Addendum #1 for
St. Joseph University Catholic Parish
Terre Haute, IN
Parish Hall
September 15, 2026

entheos ARCHITECTS
802 Lord Street, Ste. 200
Indianapolis, IN 46202
Ph (317) 951-9590

CHANGES TO THE DRAWINGS

Sheet A303 - Details

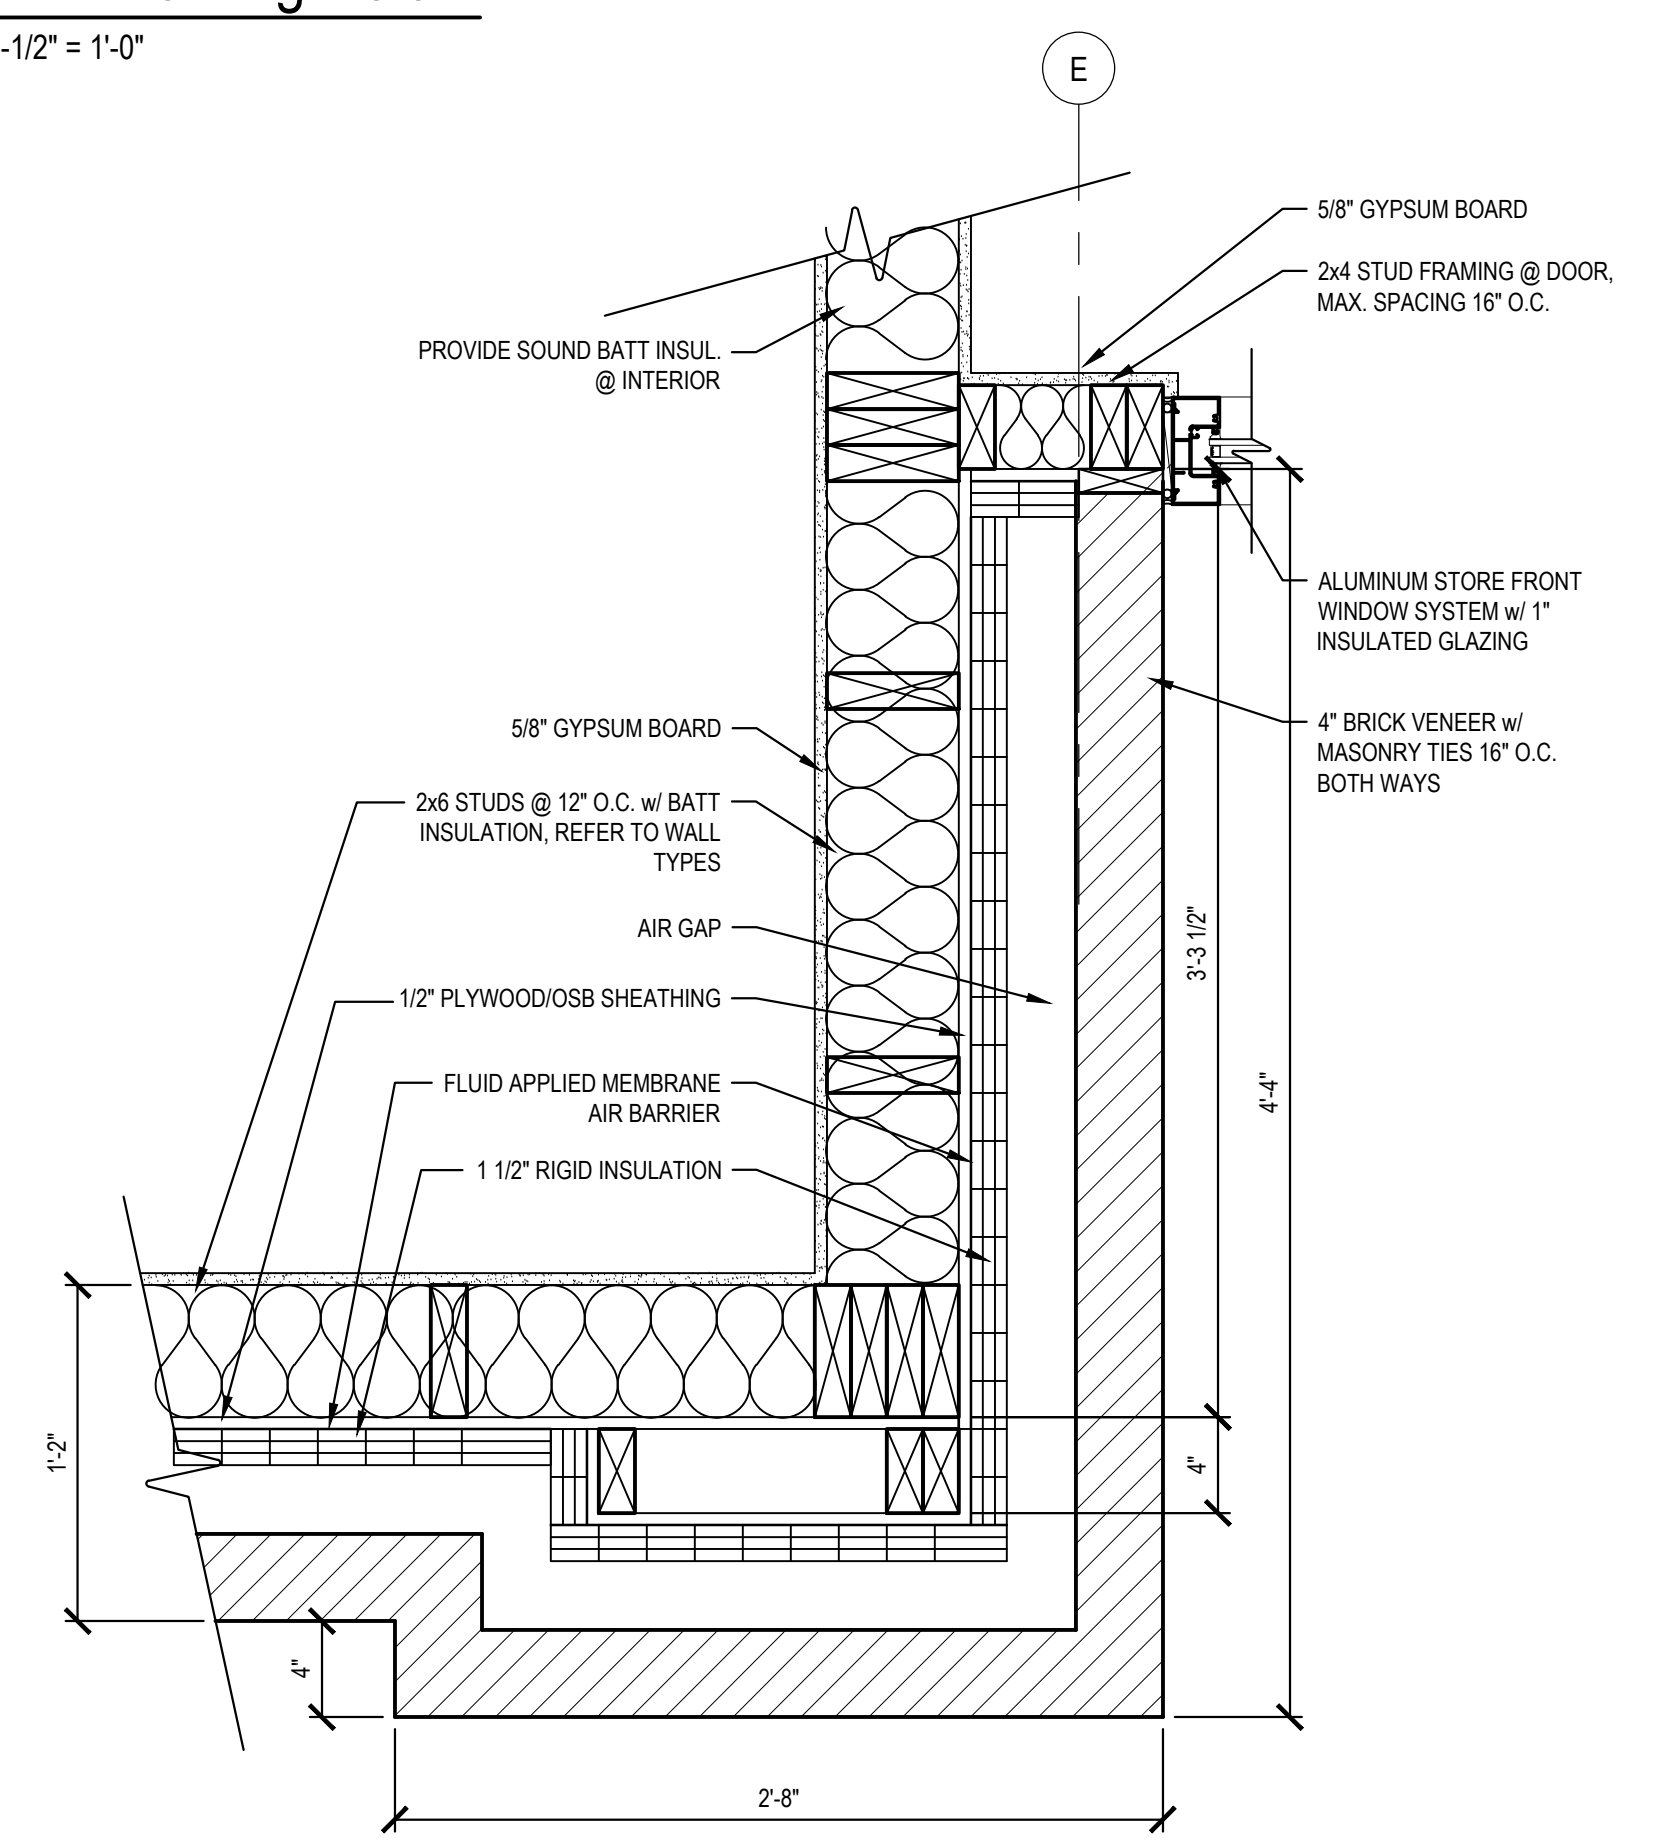
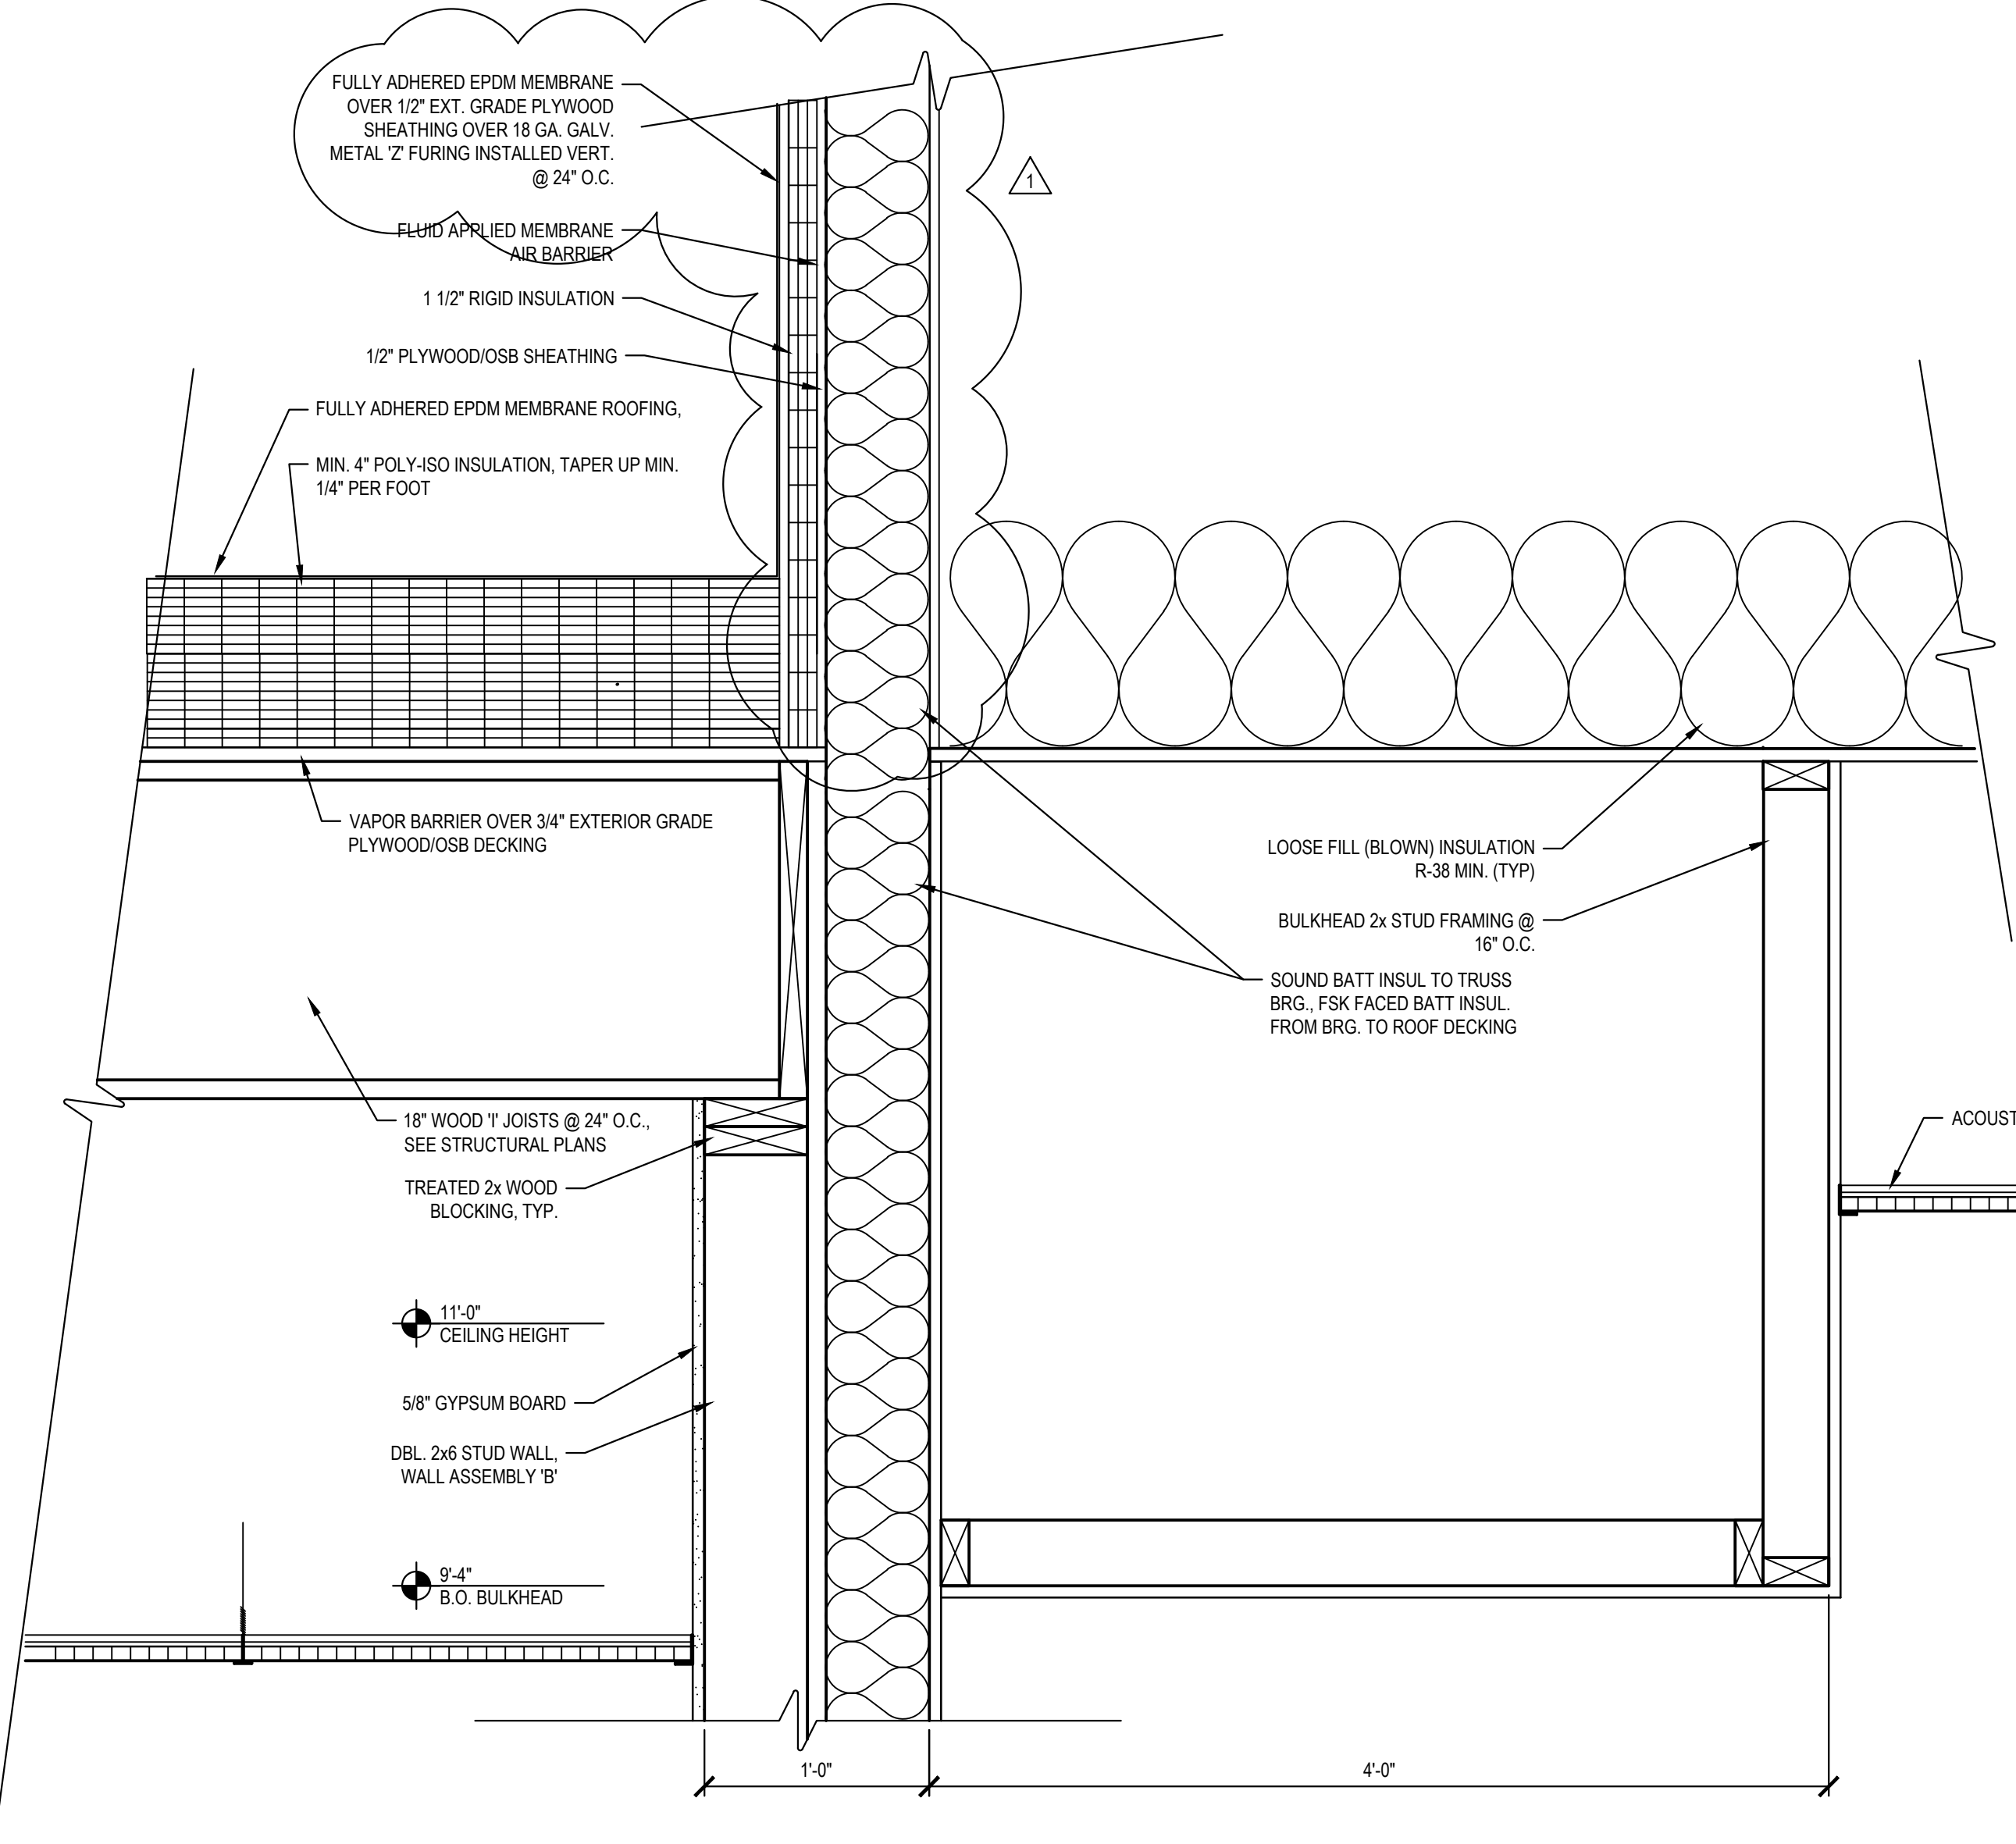
1. Revise Details as shown. Replace sheet in entirety.
